# UNITED STATES PATENT AND TRADEMARK OFFICE

**Advisory Action  
Before the Filing of an Appeal Brief**

10/067,167

KURTZ, ANTHONY D.

**Fig. 1**

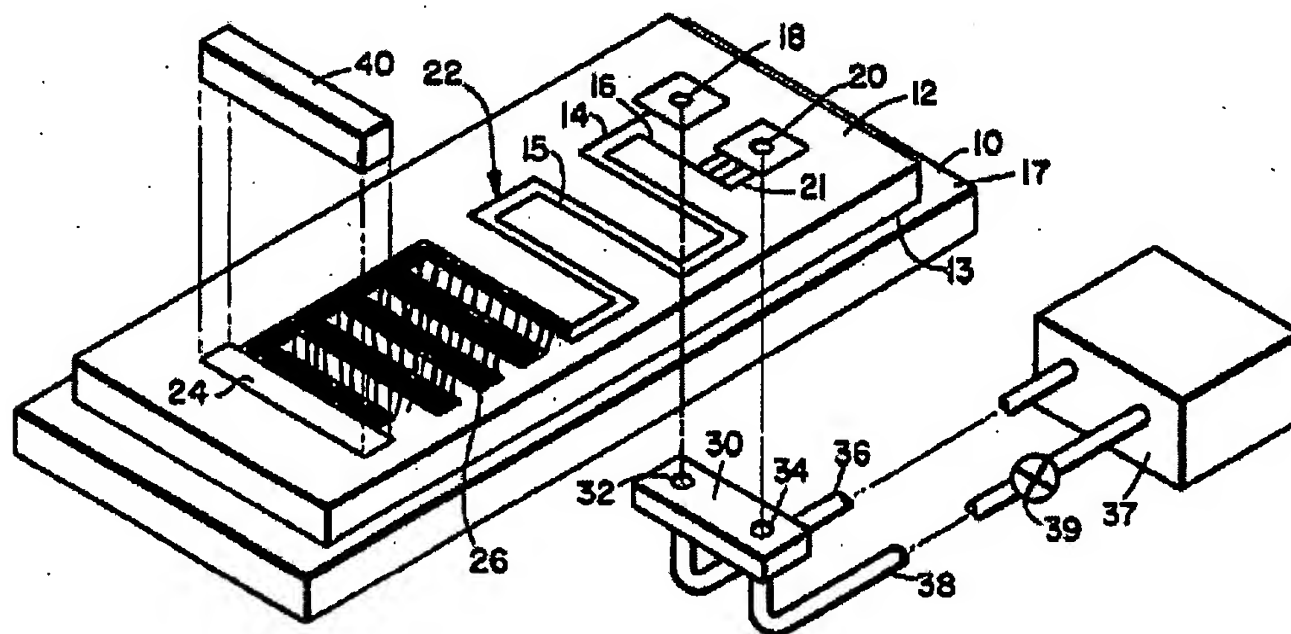
Applicant argues, with respect to claim 20, that Little fails to disclose an "edge" which would protrude into at least one of the channels and argues that the examiner "has again provided a speculative interpretation of claim language".

The examiner respectfully disagrees. It is noted that claim 20 recites only "at least one edge" without reciting a particular structural element with which the edge belongs. For further clarification, Figure 1 of the Little reference is illustrated below indicating several edges (lined area) and a channel (darkened area) in which it protrudes.
